## # Reviewer 2

**This study investigated the cause of the large daily flow fluctuations in the Mekong River. After reading the manuscript, I have a strong feeling that the manuscript needs to be carefully revised and reviewed. Precise and clear writing is important and sufficient to report the new findings to our scientific community. Especially for the figures, some irrelevant paragraphs and unclear descriptions would confuse the readers. The authors have done a lot of work to support their findings. But the current version still needs to be improved.**

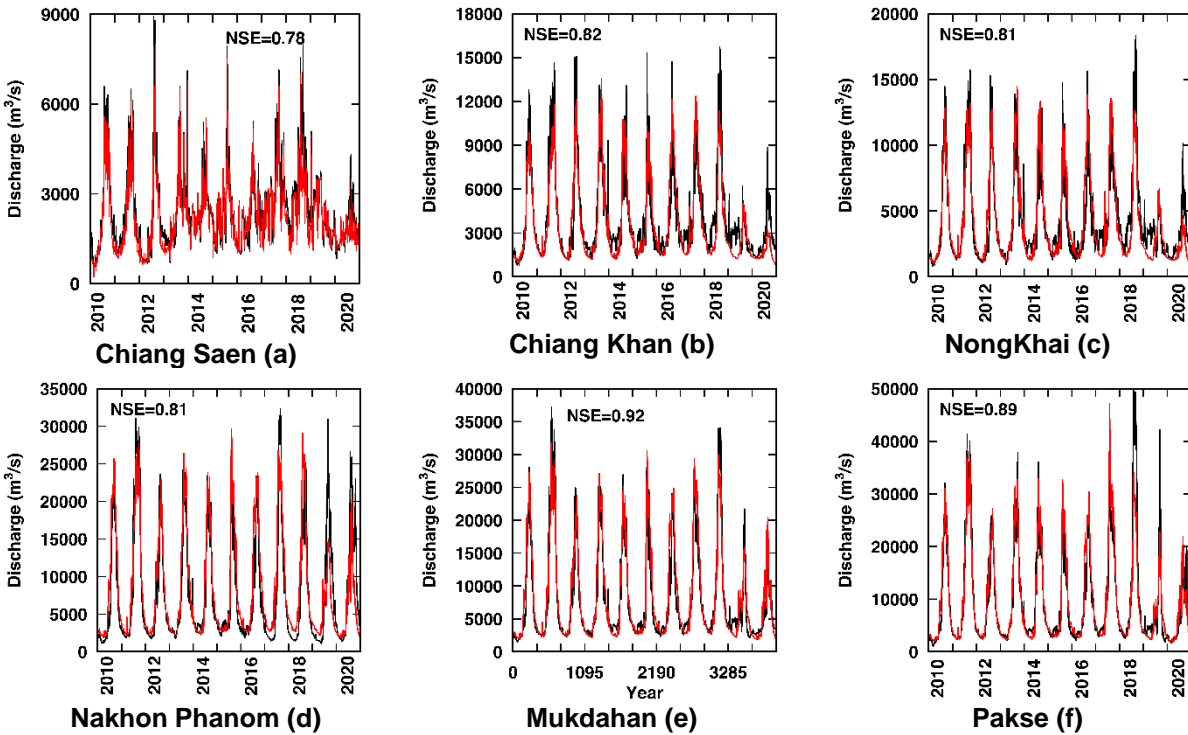
**3) This study may not be applicable to current LMRB. Given that this manuscript submitted to HESS, I am a little unsure what new insights this paper can give us regarding the LMRB, especially considering that the basin has been undergoing large-scale dam construction for 20 years. Could the authors consider looking at other areas where dam construction has not yet begun, to increase the validity of the study?**

Based on this module, comparisons were conducted for the mainstream from Chiang Saen to Stung Treng, where this study has presented the results. The overall NSE of all stations is relatively high, with NSE values exceeding 0.78 (see below Figure).

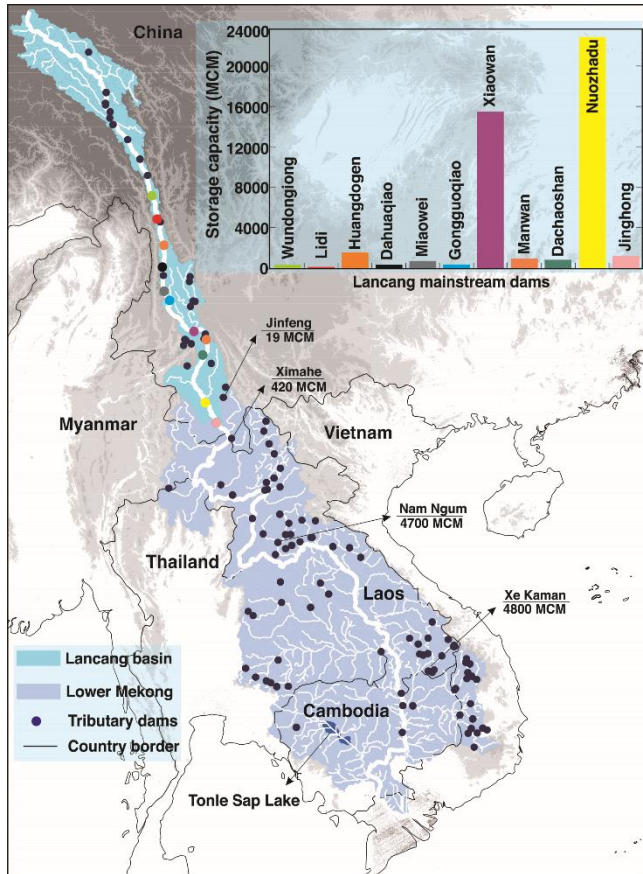
**8) In Figure 1, what is "the Tonle Sap Lak"? It is recommended that the author carefully checks for the spelling and grammatical errors in the paper, as similar situations occur frequently.**

**Response:** The first author apologizes for the oversight. It should indeed be "Tonle Sap Lake." Below is the updated version of Figure 1.

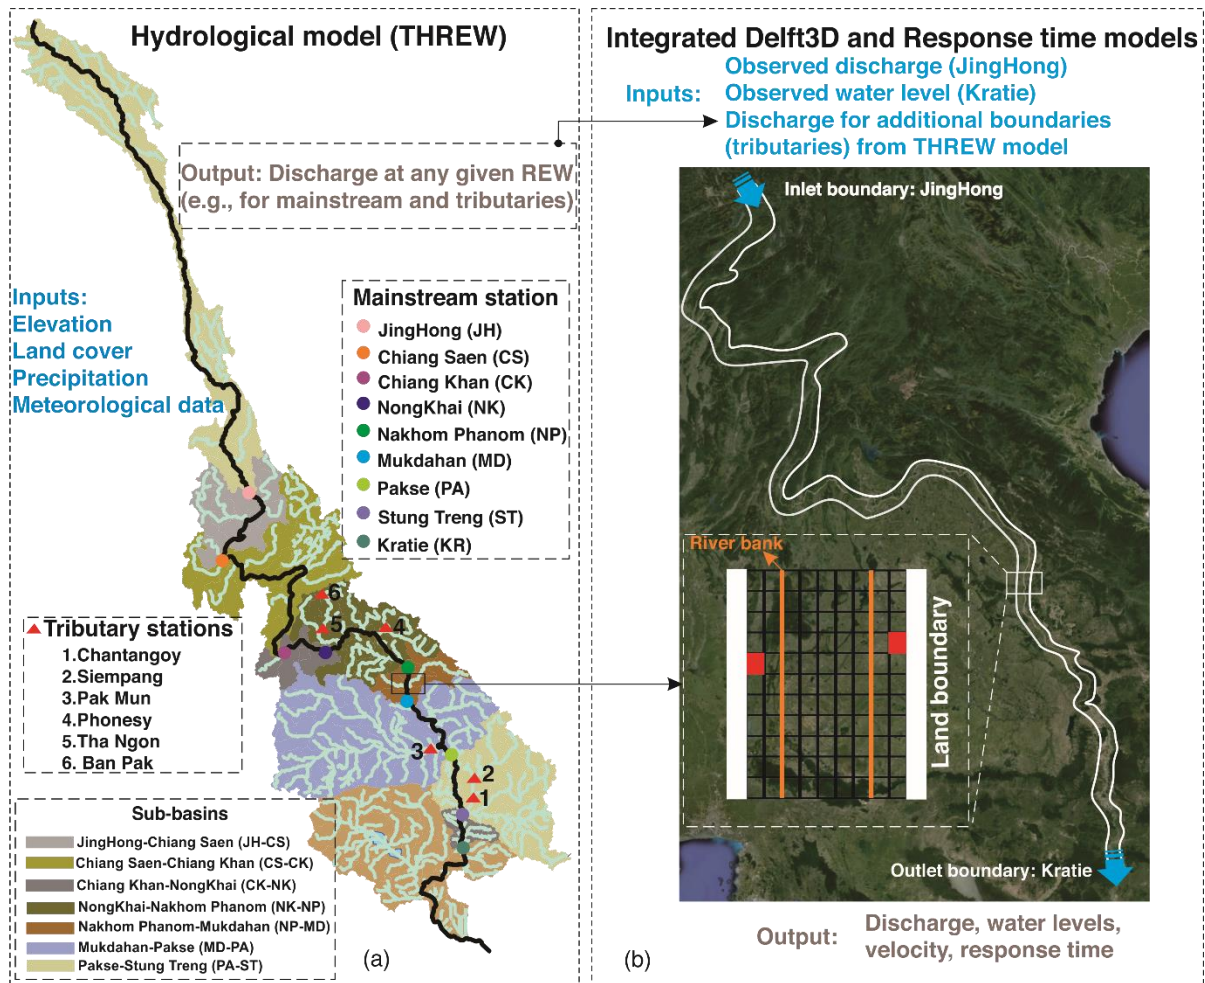
9) In Figure 2, I don't think it's a good idea to use both red circles and triangles for labeling. I can't distinguish the tributary station and the mainstream station at all. Besides, I think there should be a space separating the "Delft3D".

In the revised version of Figure 2 (see comment 9), the added part in the right panel shows how additional boundaries are considered in the hydrodynamic model. We mentioned in the paper that the land boundary is considered greater than the river bank. One cell was allocated to each defined tributary. This shows that the outlet discharge of the REW, which is close to the mainstream, was used to define the tributaries in the computational domain of the hydrodynamic model.

**Response:** Thanks for your feedback and suggestions. We use different colors for labeling as you've suggested. The updated version of Figure 2 is as follows:

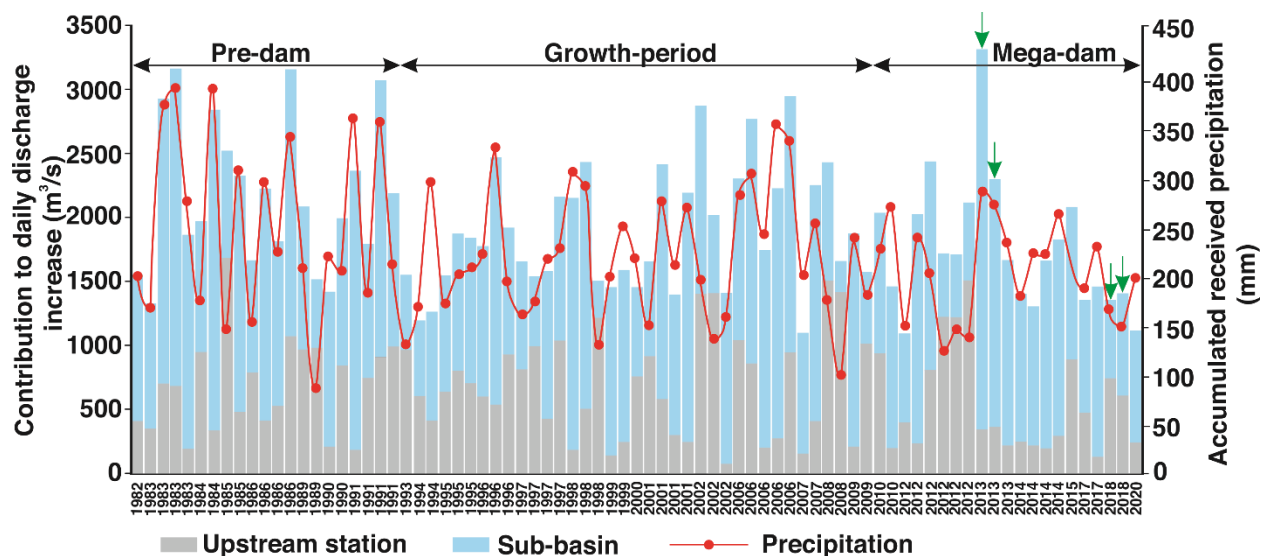
**12) In Figure 9, I don't think it's a good idea to remove the year labels on the x-axis of the time series graph, as this only makes the figure harder to understand. Also, what is "recieved rainfall"? It is recommended to avoid the use of rainfall and to use precipitation uniformly.**

**Response:** Thanks for your feedback and suggestions. We have added the years to the x-axis.

We will use "precipitation" instead of "rainfall" as suggested. Regarding the font sizes, we acknowledge that there are discrepancies among figures, and we will make specific adjustments accordingly. Figure 9 has been updated accordingly.

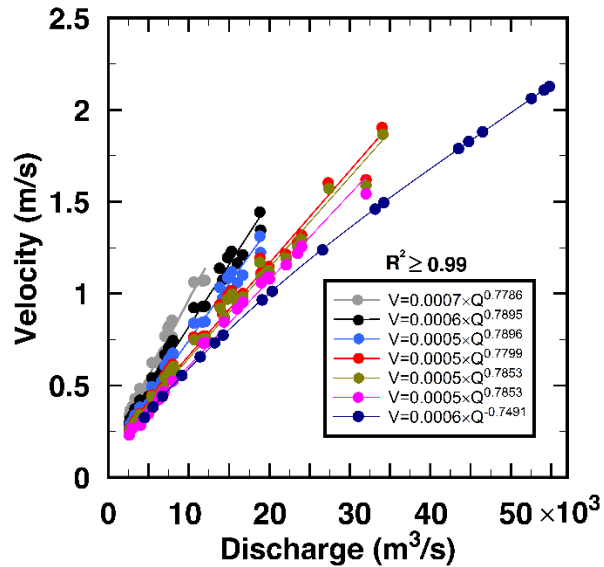
**14) In Figure 11, Please add dots of corresponding colors on the basis of the lines in the legend, which can make the image more readable.**

**Response:** Thanks for your suggestion. We have added the dots in the legend as recommended. Thank you.
